**COUNTY OF WESTCHESTER
NEW YORK
DEPARTMENT OF PUBLIC WORKS
AND TRANSPORTATION
DIVISION OF ENGINEERING
ADDENDUM NO. 2
CONTRACT NO. 23-519
FOR
ROOF, HVAC, AND ELECTRICAL UPGRADES
DANIEL P. THOMAS MATERIAL RECOVERY FACILITY
YONKERS, NEW YORK**

**CONTRACT NO. 23-519
ROOF, HVAC, AND ELECTRICAL UPGRADES
DANIEL P. THOMAS MATERIAL RECOVERY FACILITY
YONKERS, NEW YORK**

Partial Roof Construction Plan - Materials Recovery Facility & Tipping Floor

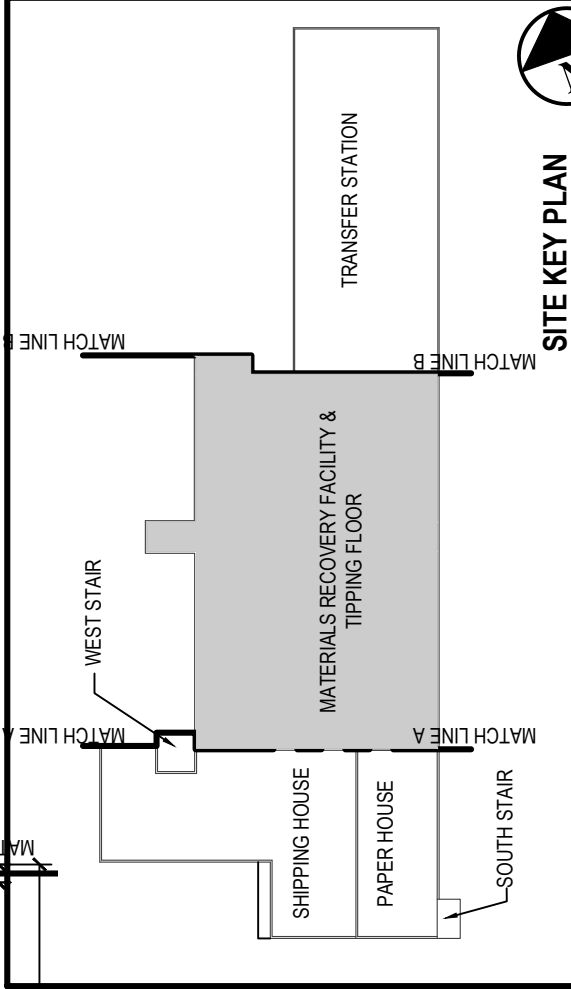
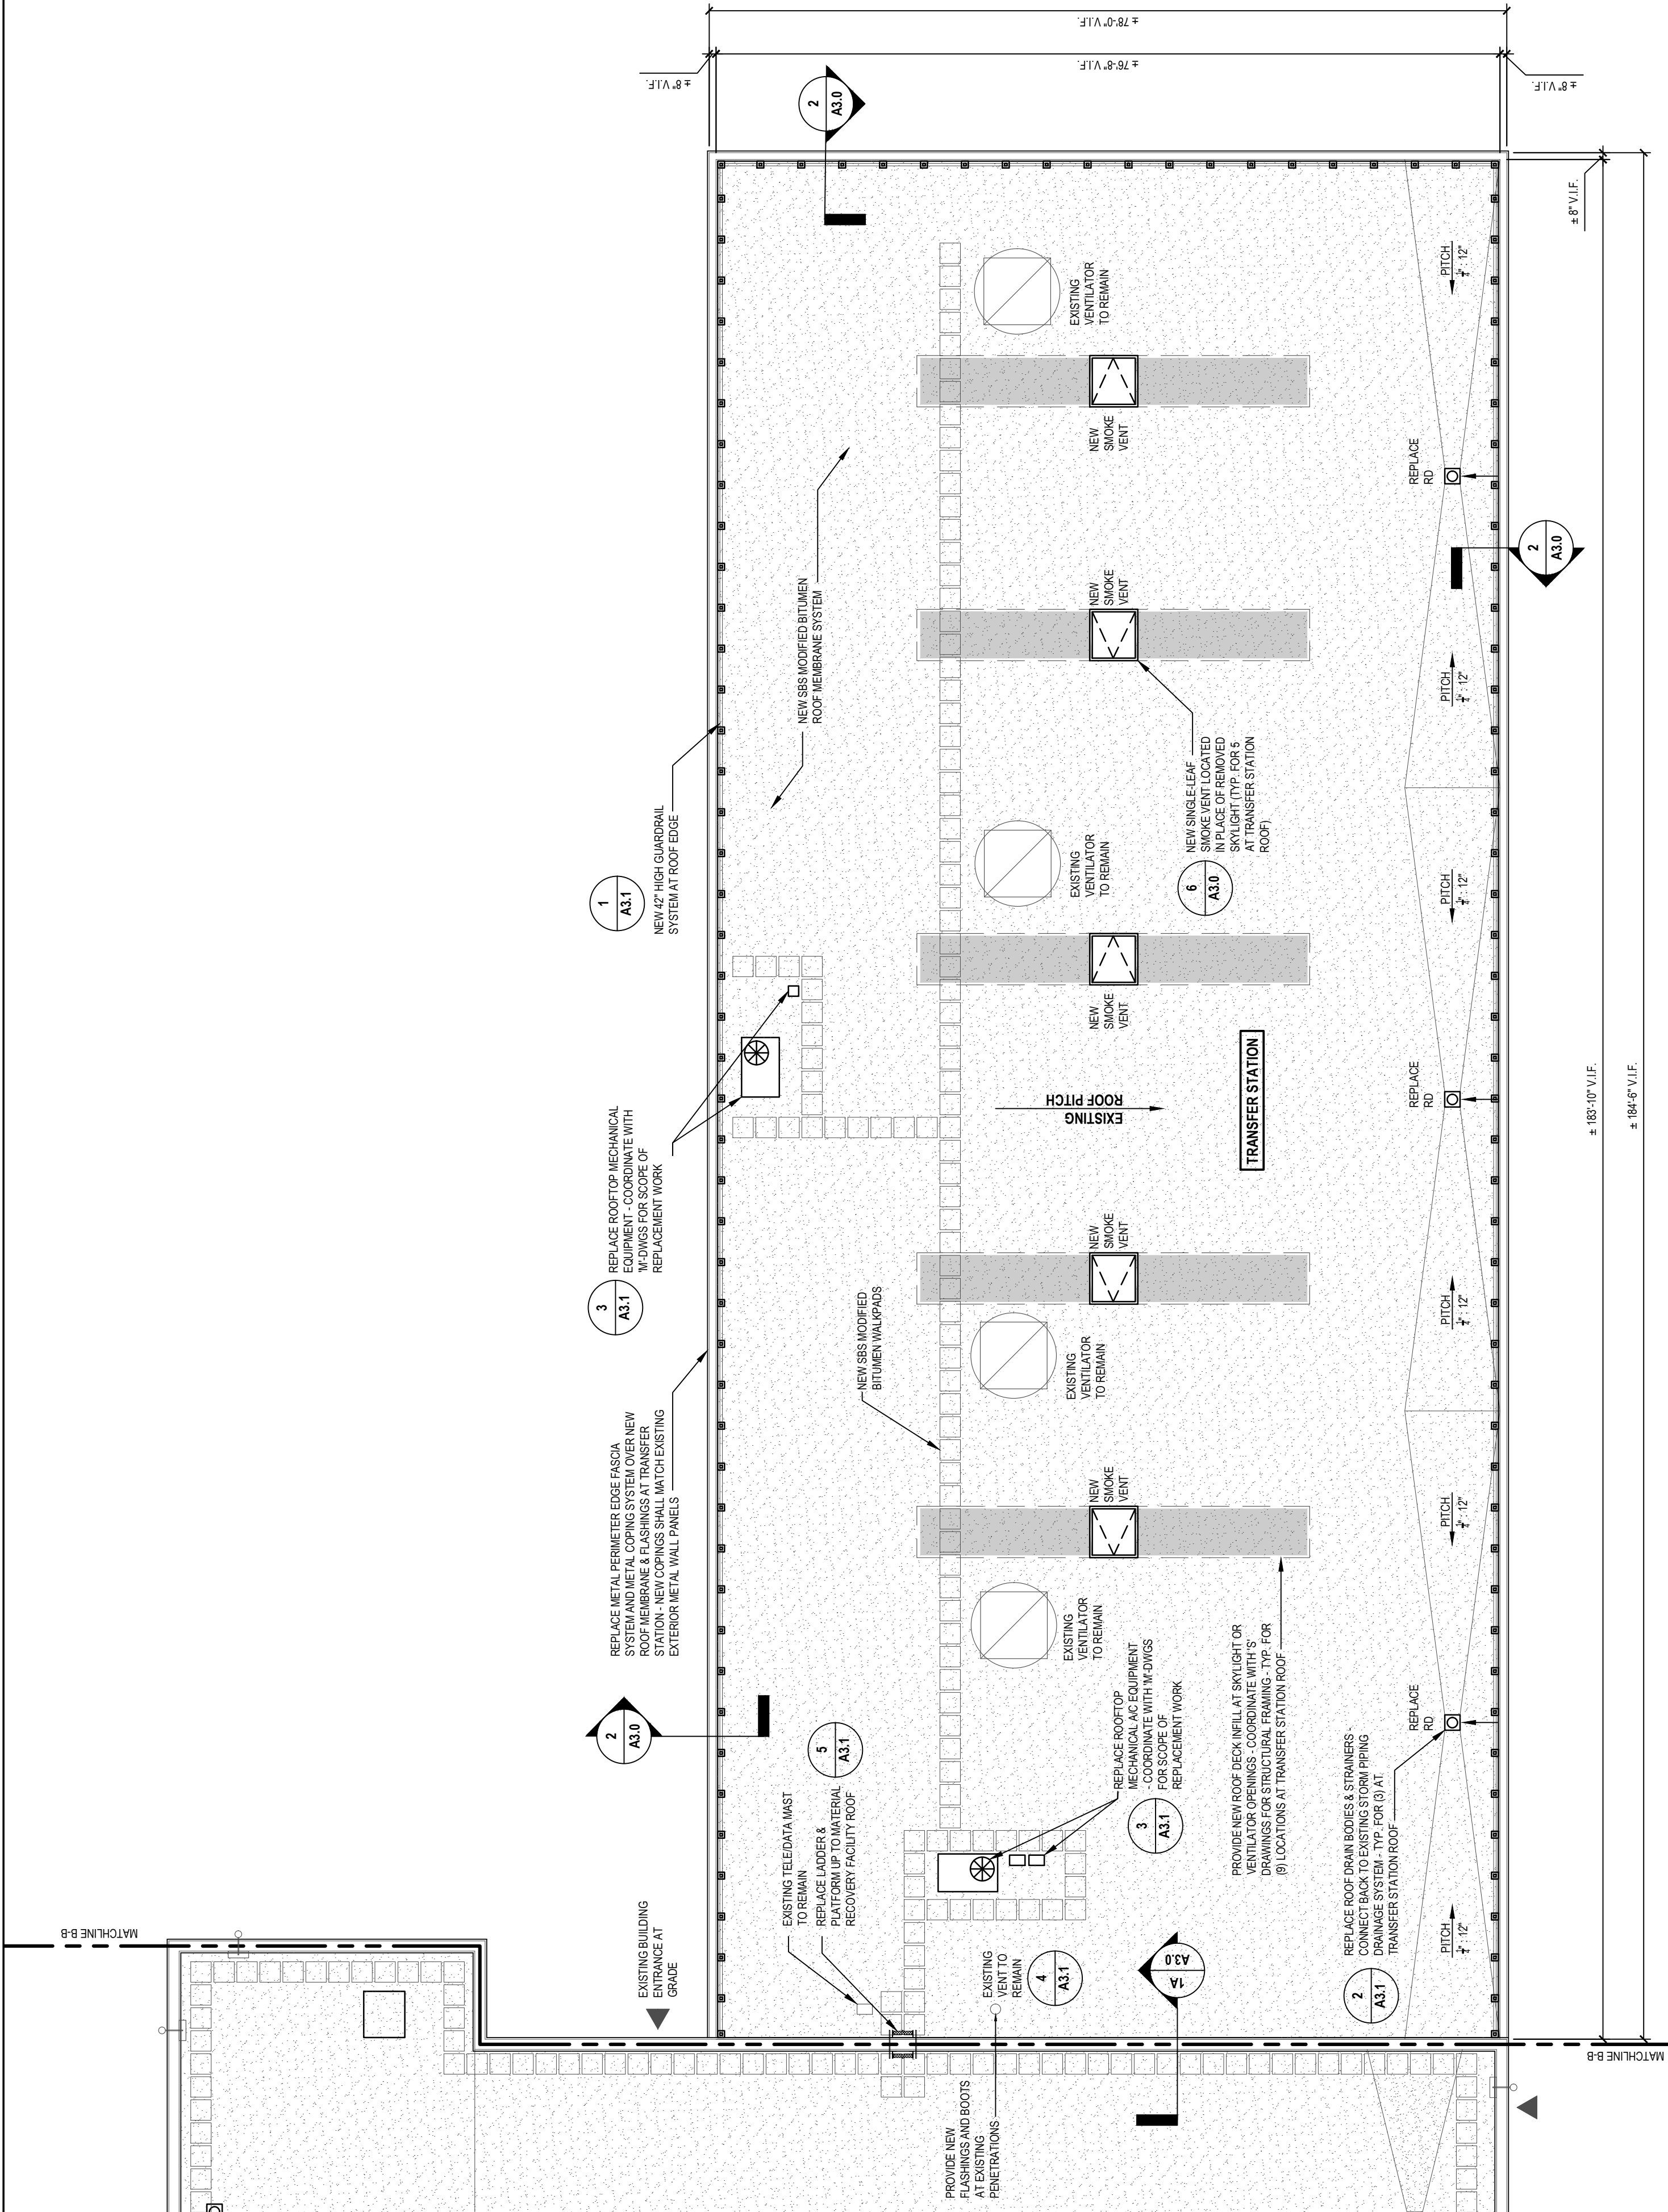
5. A2.1:
 - ❖ **Miscellaneous annotations throughout are revised to remove references to Contracts ‘G’, ‘M’ and/or ‘E’. This project will be Single Prime. See attached.**

Partial Roof Construction Plan - Transfer Station

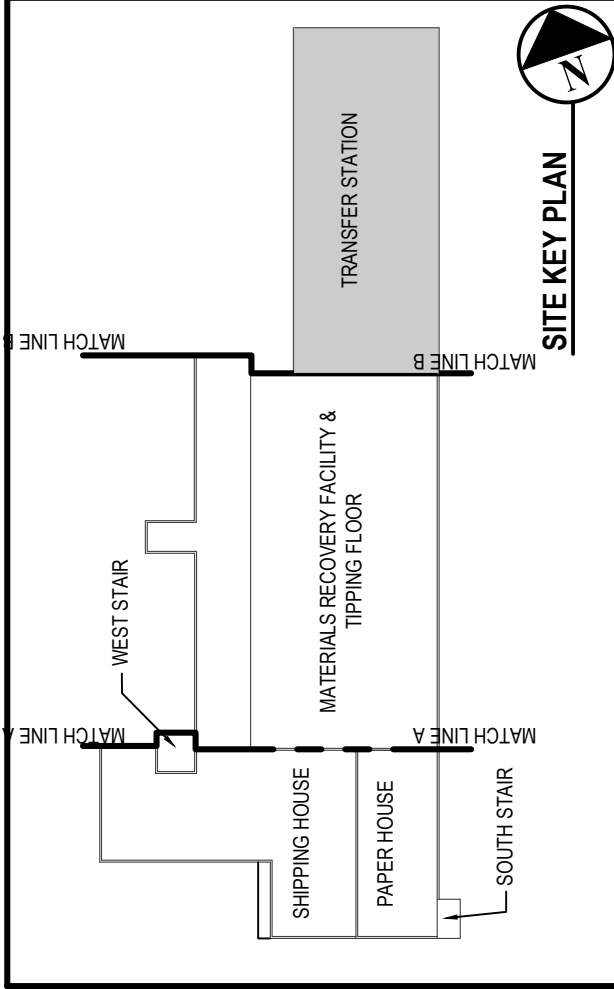
6. A2.2:
 - ❖ **Miscellaneous annotations throughout are revised to remove references to Contracts ‘G’, ‘M’ and/or ‘E’. This project will be Single Prime. See attached.**
